Marin County Flood Control and Water
Conservation District
**Corte Madera Creek Flood Risk Management
Project, Phase 1**
Final Environmental Impact Report
Volume 1: Comments and Responses to Comments
State Clearinghouse No. 2020080353

**Marin County Flood Control and Water
Conservation District
Corte Madera Creek Flood Risk Management
Project, Phase 1
Final Environmental Impact Report
Volume 1: Comments and Responses to Comments
State Clearinghouse No. 2020080353**

Figure 2-11 Alternative 1 Changes in Water Surface Elevation from Future Conditions, 100-Year Flood Event (Upper Corte Madera Creek)

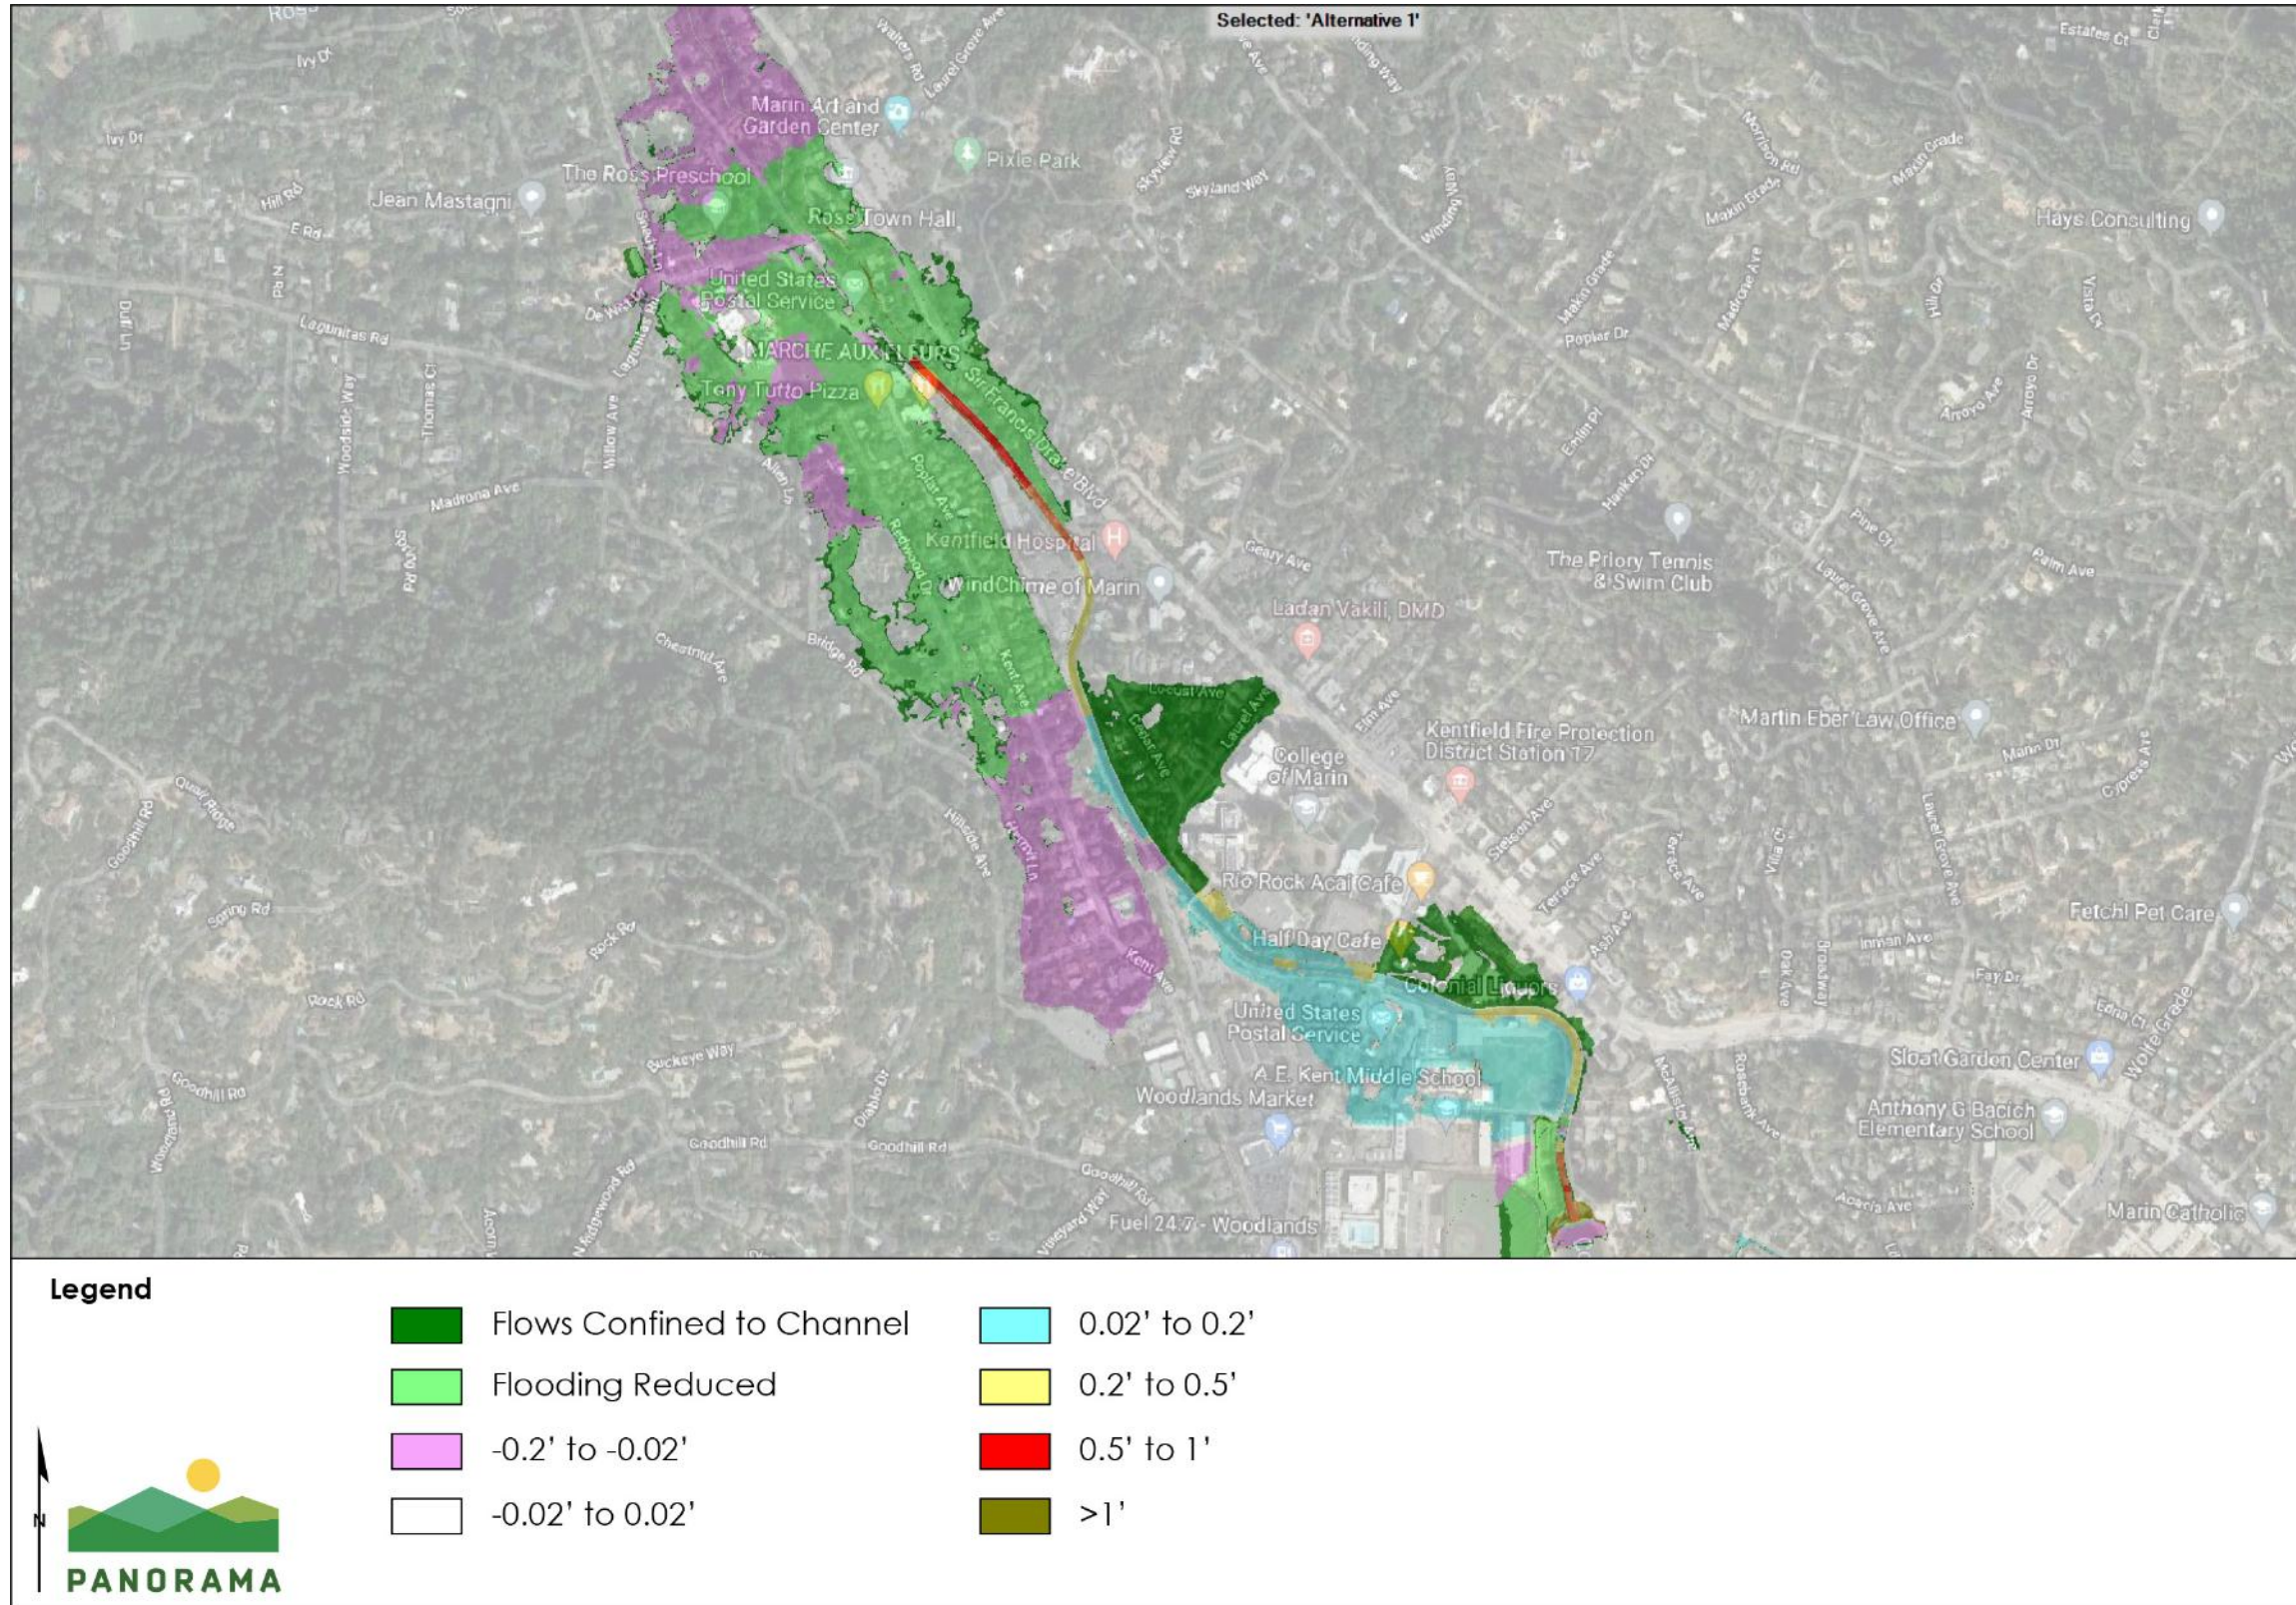
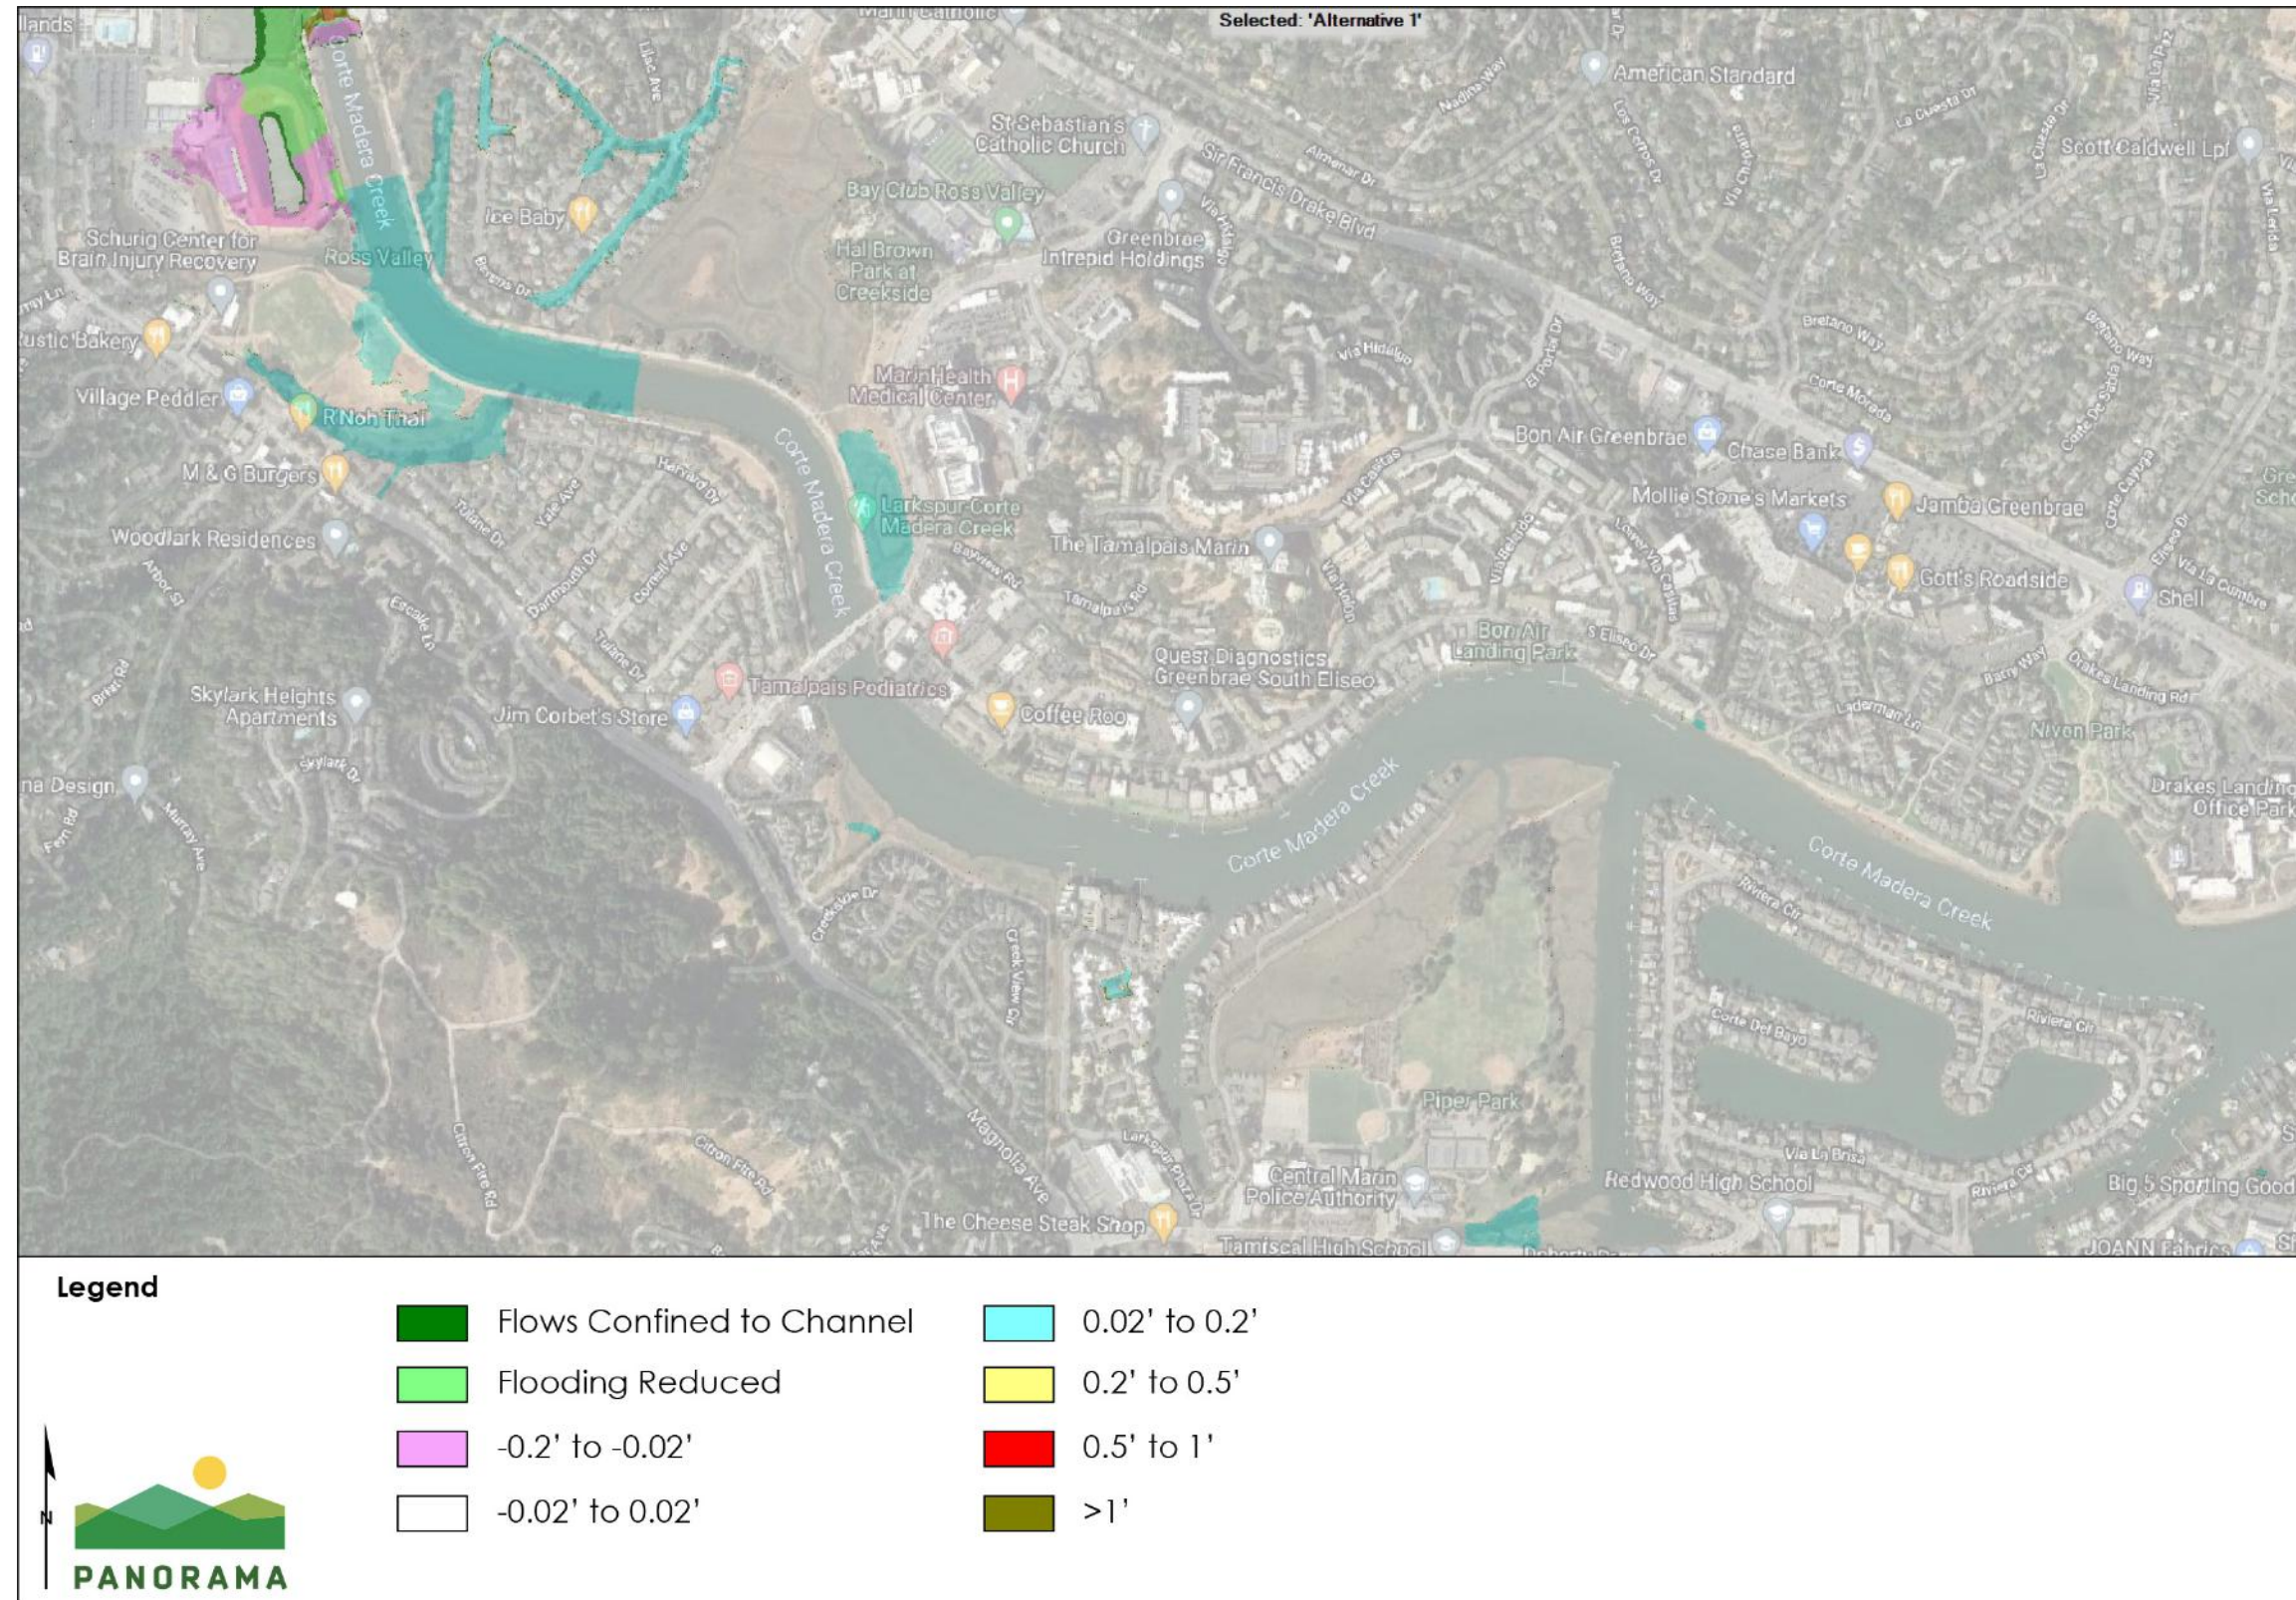
The geographic extent of the figures showing the changes in WSE differs from the figures included in the Draft EIR. The geographic extent of the figures was expanded to show areas downstream from Unit 2 in response to comments from the City of Larkspur. As discussed on page 3.9-39 in the Draft EIR, a threshold of 0.2 foot (2.4 inches) was used for determining whether a potentially significant increase or decrease in WSE would occur at any structure. The 0.2-foot threshold is a reasonable level of precision for evaluating flooding impacts, considering the standards for accuracy and precision associated with hydraulic modeling.

Figure 2-1 through Figure 2-6 show the Alternative 1 changes to the WSE and reflect the difference in WSE between the Existing Condition Without Project and Existing Condition With Alternative 1 scenarios under a 10-, 25-, and 100-year flood, using the updated modeling for the 60 percent design. Figure 2-7 through Figure 2-12 show the Alternative 1 changes to the WSE under for the future condition scenario, and reflect the difference in WSE between the Future Condition Without Project and Future Condition With Alternative 1 under the 10-, 25-, and 100-year flood conditions. The assumptions used in the future condition modeling are described on pages 3.9-35 through 3.9-37 in Section 3.9 in the Draft EIR and are supplemented by the model updates described above. Figure 2-13 through Figure 2-18 show the Alternative 1 changes to the WSE under a “high-emissions likely” sea-level rise scenario, to reflect 2100 projected sea-level rise based on the 2018 Update of the State of California Sea-Level Rise Guidance (California Ocean Protection Council, 2018). Figures 2-13 through 2-18 reflect the difference in WSE between the Year 2100 Future Condition Without Project and Year 2100 Future Condition with Alternative 1 scenarios under the 10-,25-, and 100-year flood conditions.

Areas shown in the figures as “Flows Confined to Channel” are areas that are currently flooded by Corte Madera Creek, which are predicted to no longer have flood inundation from Corte Madera Creek overtopping after Alternative 1 is implemented. Areas shown in the figures with “Flooding Reduced” are areas with reduced flood inundation (greater than 0.2 foot) from creek overtopping after Alternative 1 is implemented. The change in WSE shown on the maps reflects a comparison between WSE without implementation of Alternative 1 and the WSE after implementation of Alternative 1 for each modeled scenario.
